**Compton Community College District
1111 E. Artesia Blvd.
Compton, CA 90221**

DATE: October 22, 2018
TO: All Bidders
PROJECT: RFQ CCC-053
Campus Drive DG & Landscape
SUBJECT: ADDENDUM #1

Addendum #1 - October 22, 2018

Detail 1A:

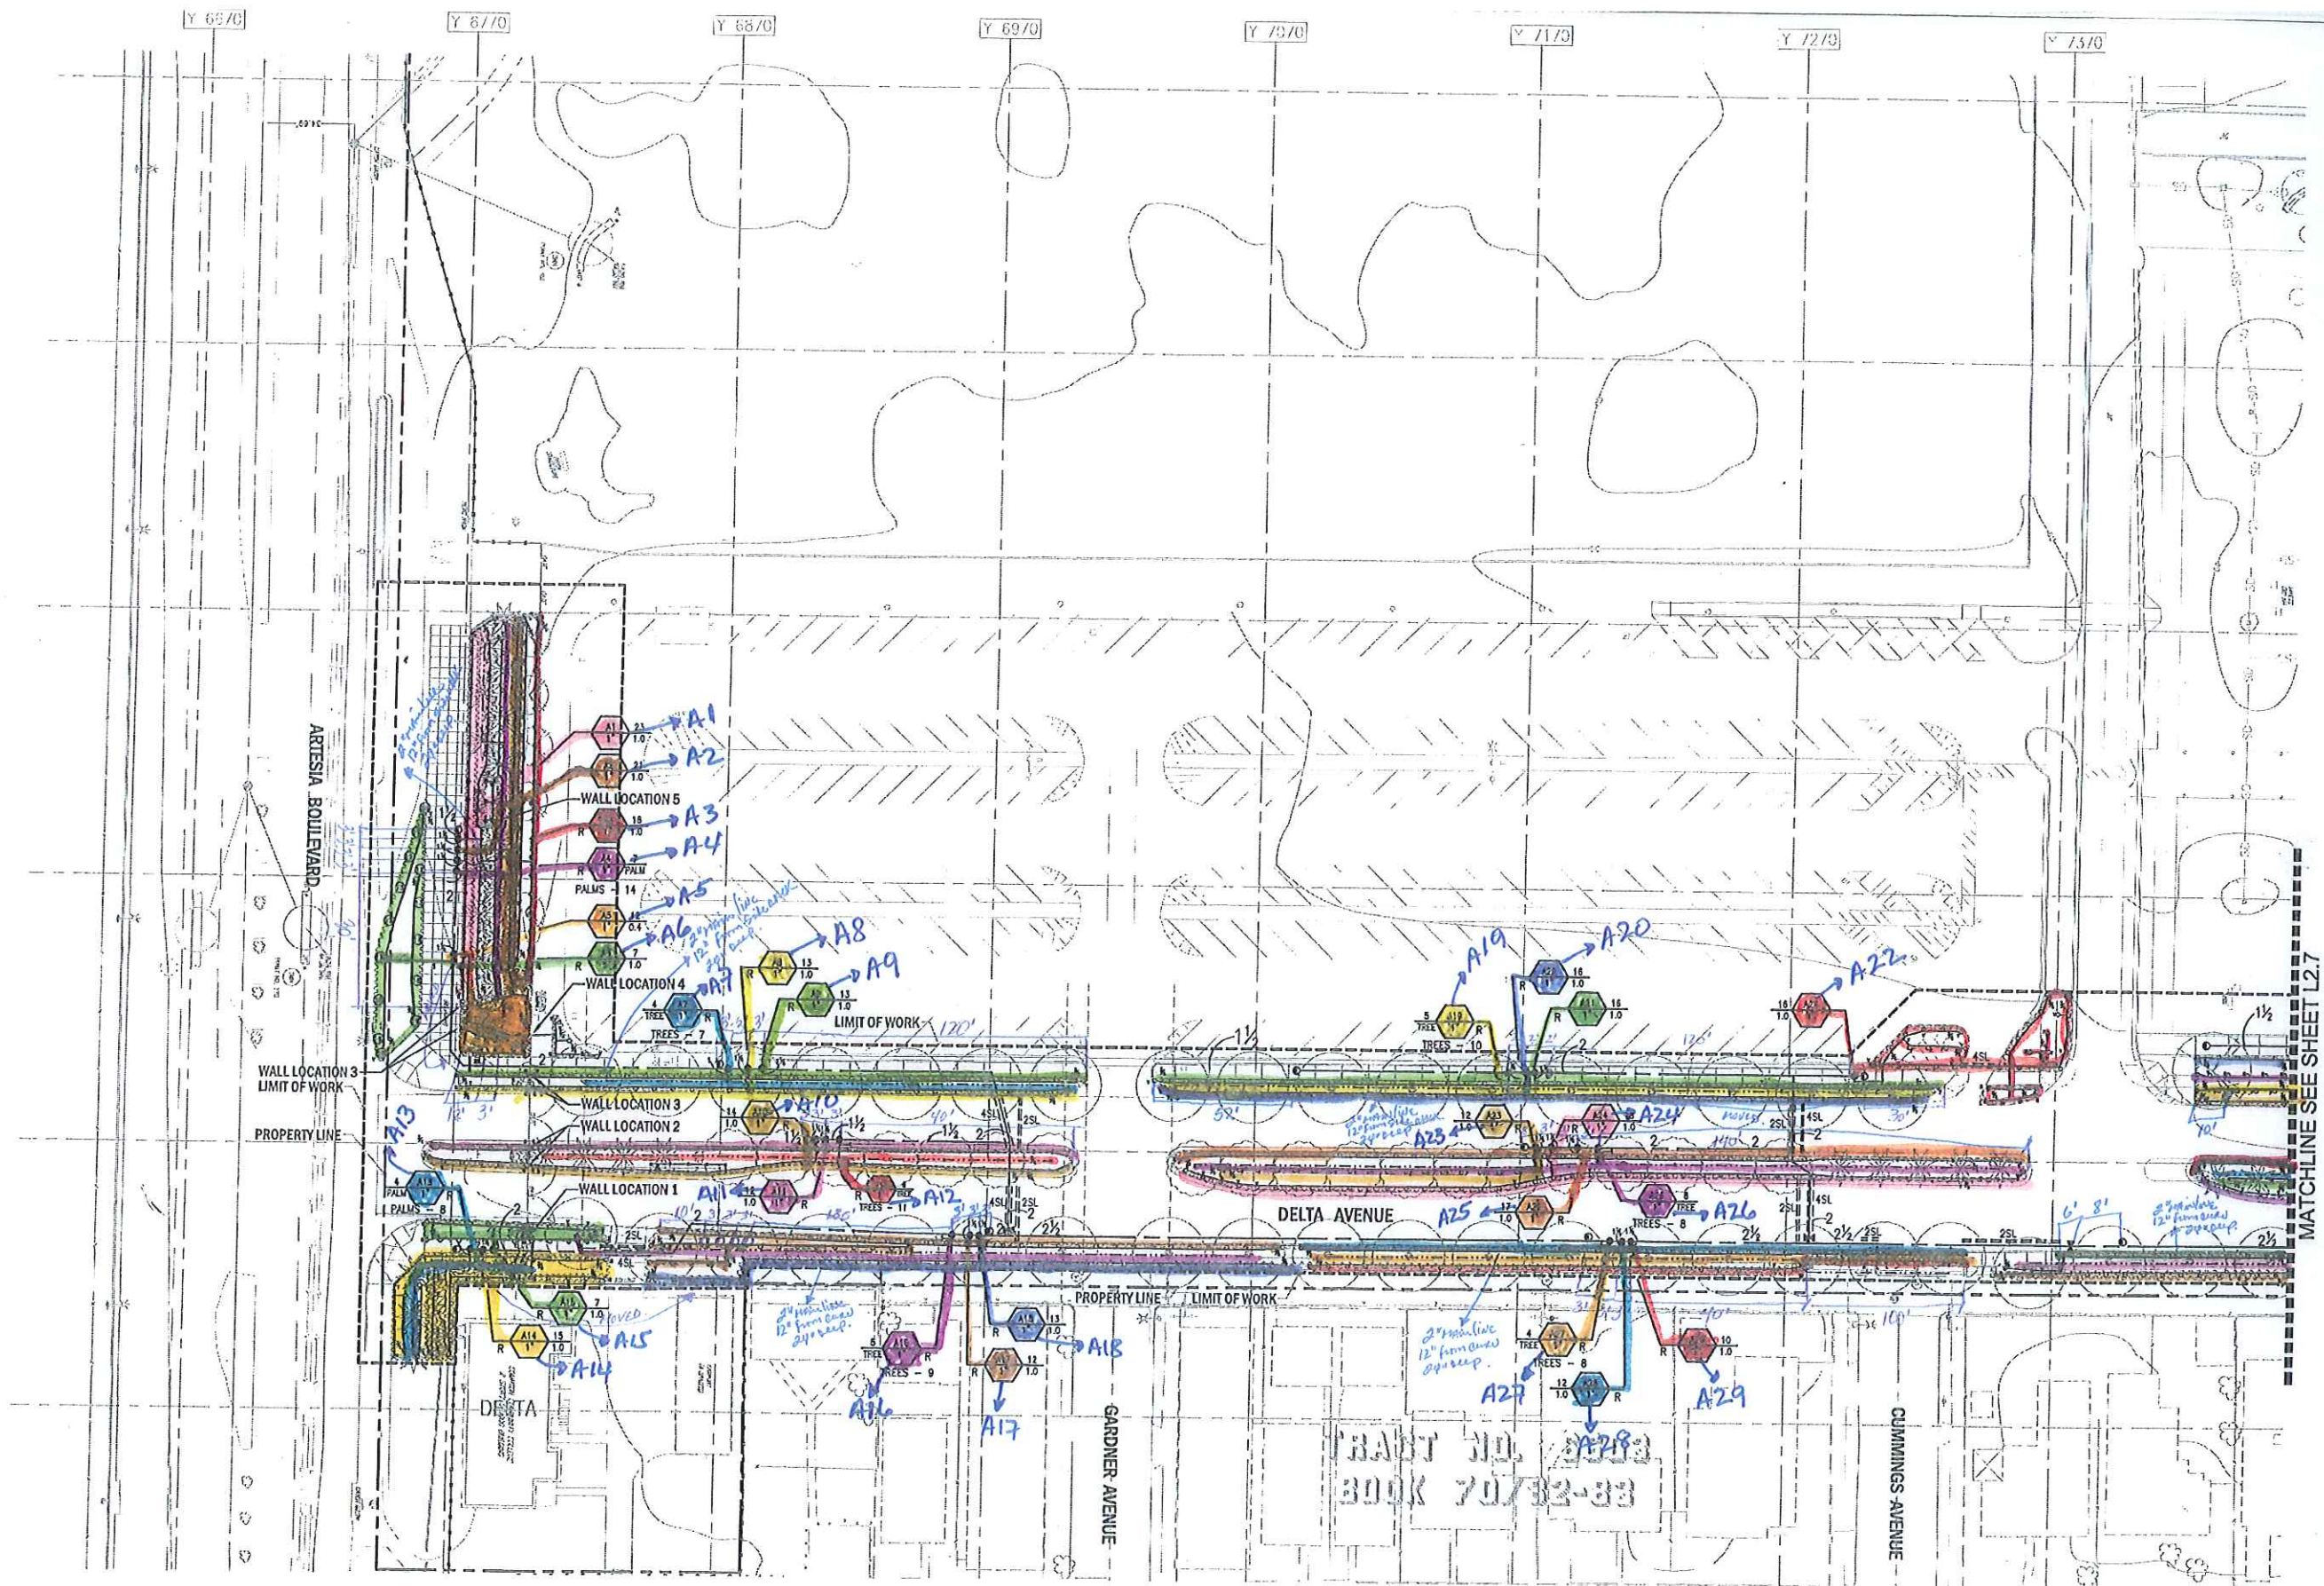
12	There is established bougainvillea along the fence line in zone 21, 24, 28 and 30 which is creating a natural screen between the College and neighbors. Please confirm this is to be left in place with trimming only to allow the installation of other SOW items.		Confirmed - Bougainvillea is to be trimmed back to within 12" of existing fence line. See attached detail 1A for the areas along the west property line. Redwood header is to be placed at approximately 12" away from the existing fence line.
13	At Zones 21, 24, 28 - is the DG from curb to fence line, leaving the bougainvillea in place? If not, what is the required width of the DG area?		Excavate as required & replace w.D.G. to approximately 12" away from the fence and bougainvillea. Protect existing bougainvillea and fencing in place.
14	At Zones 25, 31, 32 it states we are to trim existing plants, remove weeds and make irrigation repairs. Please confirm these areas are NOT to also receive new DG per 1.2.A.1 and 1.2.A.1.E-G.	Scope of Work 1.2.A	Confirmed - Areas 25, 31 and 32 do not receive D.G.

1. Fencing and Planting along fence to be protected in place
